SERVICE BULLETIN

APPLICABILITY: 2020-24MY Legacy 2.4L
 2020-24MY Outback 2.4L
 2019-24MY Ascent
 2022-24MY WRX
 2022-25MY Outback Wilderness

NUMBER: 16-150-24R

SUBJECT: Transmission Control Module (TCM) / Software Enhancement

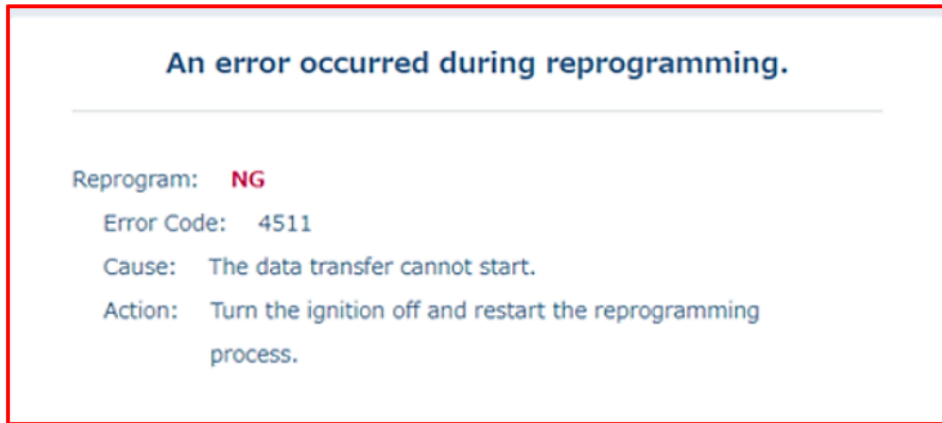
After clicking the line, does the detail text box display stating “The TCM cannot be reprogrammed, replace the TCM with latest superseded part”?

This TCM cannot be reprogrammed, replace TCM with the latest superseded part.

YES: The TCM is **NOT** suitable for reprogramming. Continue to Step 3.

NO: The TCM is suitable for reprogramming. Perform the SSM5-R reprogramming procedure.

SYMPTOM 1:

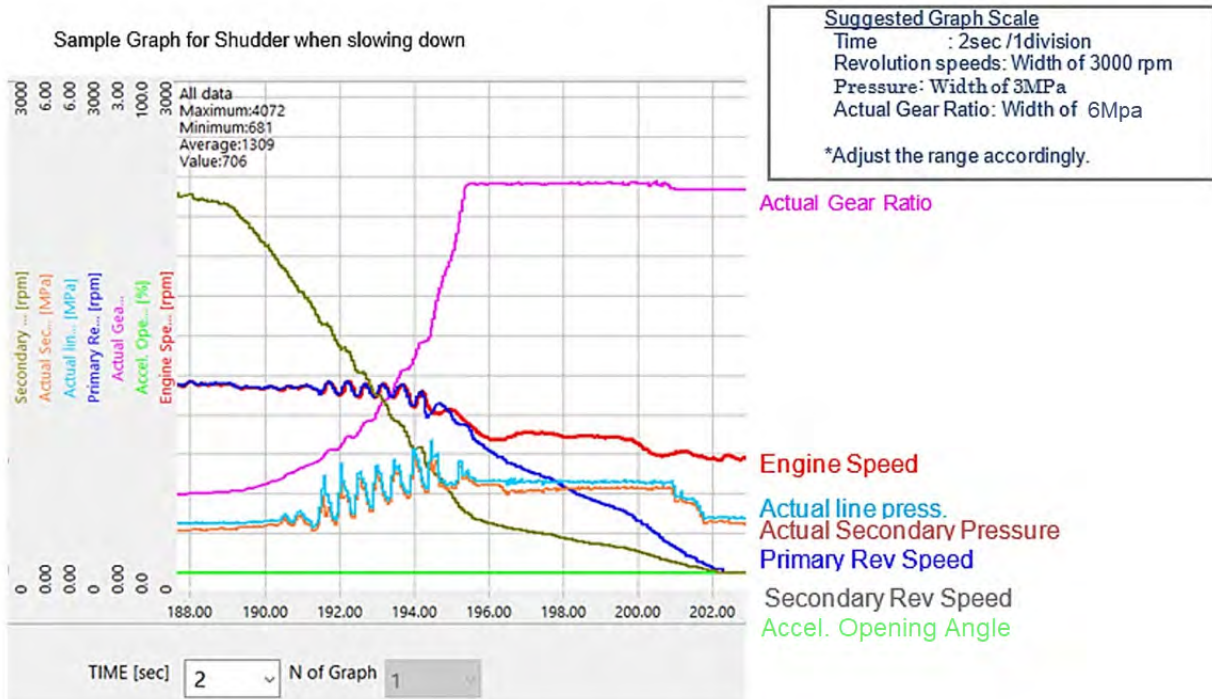
Actual line press. and Actual Secondary Pressure are fluctuating while feeling shudder when slowing down

SYMPTOM 2:

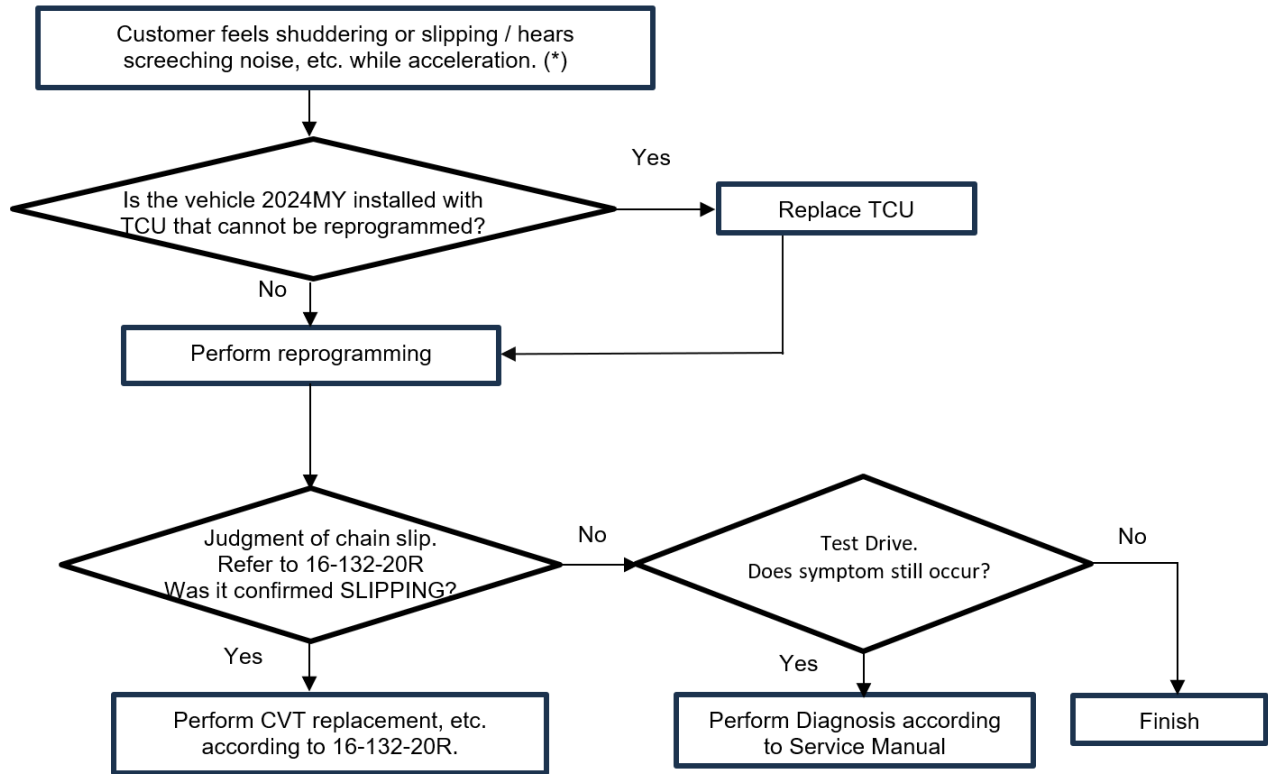
(*) **NOTE:** In case of chain slip caused by input clutch slip, customers may experience symptoms under the following driving conditions.

- (1) Constant speed driving between 25 and 62 mph.
- (2) Gentle acceleration between 25 and 62 mph.

- All of the following are satisfied.
- Primary UP Duty > 80 %
 - Actual Pulley Ratio changes to Low
 - Above conditions last for 0.5sec or more

Suggested Graph Scale
 Time : 2sec /1division
 Revolution speeds: Width of 6000 rpm
 Actual Gear Ratio: Width of 3.0
 Primary UP Duty: 0 - 100 %
 *Adjust the range accordingly.
